Access Compliance Report

Public Rights-of-Way

(Curb Ramps)

Intersection ID: 21497	Main Street: GREENWAY_VIEW_CT	Cross Street: WITHERS_MILL_DR	Location:	N
ADA ID: F7EA137B0D44	Ramp Type: BlendTrans2	Initial Pass/Fail: Fail	Overall Compliance: No	Severity Score: 35

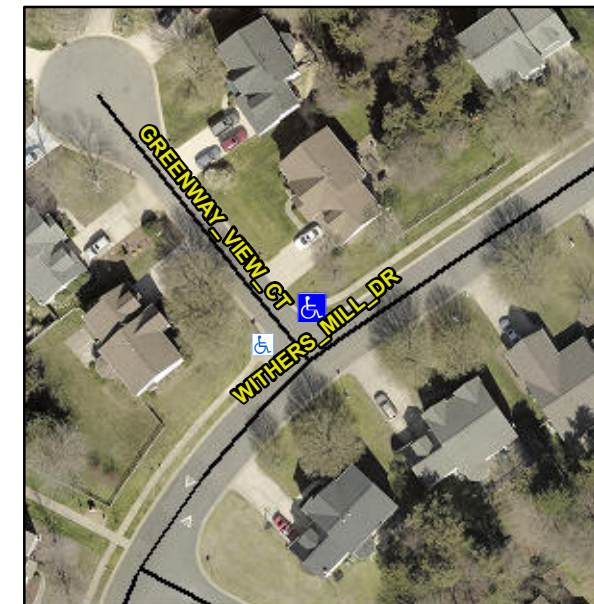
R304.5.1

Compliance	Description	Data	Compliance	Description	Data
N/A	Ramp Length (in)	102.0	Yes	BlendTrans Slope (%)	2.1
No	Ramp Width (in)	24.0	Yes	BlendTrans XSlope (%)	0.0
N/A	Flare Type LT	N/A	N/A	Flare Type RT	N/A
N/A	Flare Slope LT (%)	N/A	N/A	Flare Slope RT (%)	N/A
N/A	Flare Traversable LT?	N/A	N/A	Flare Traversable RT?	N/A
N/A	Landing Length (in)	N/A	N/A	DWS Provided?	N/A
N/A	Landing Width (in)	N/A	N/A	DWS Contrast?	N/A
N/A	Landing Slope (%)	N/A	N/A	DWS Length (in)	N/A
N/A	Landing X Slope (%)	N/A	N/A	DWS Full Width?	N/A
N/A	Landing Curb? (Y/N)	N/A	N/A	DWS Offset (in)	N/A
N/A	Shared Landing?	N/A			
N/A	Gutter Ponding?	N/A	N/A	Gutter Slope (%)	N/A
N/A	Gutter Lip Ht (in)	N/A	N/A	Gutter X Slope (%)	N/A
N/A	Painted X Walk1?	No	N/A	Painted X Walk2?	No
	X Walk 1 Direction	To SW		X Walk 2 Direction	To SE
	X Walk 1 Width (in)	N/A		X Walk 2 Width (in)	N/A
	X Walk 1 Slope (%)	2.2		X Walk 2 Slope (%)	2.1
	X Walk 1 X Slope (%)	1.7		X Walk 2 X Slope (%)	2.2

Remove & Replace Curb Ramp With Two New Directional Ramps or Equivalent.
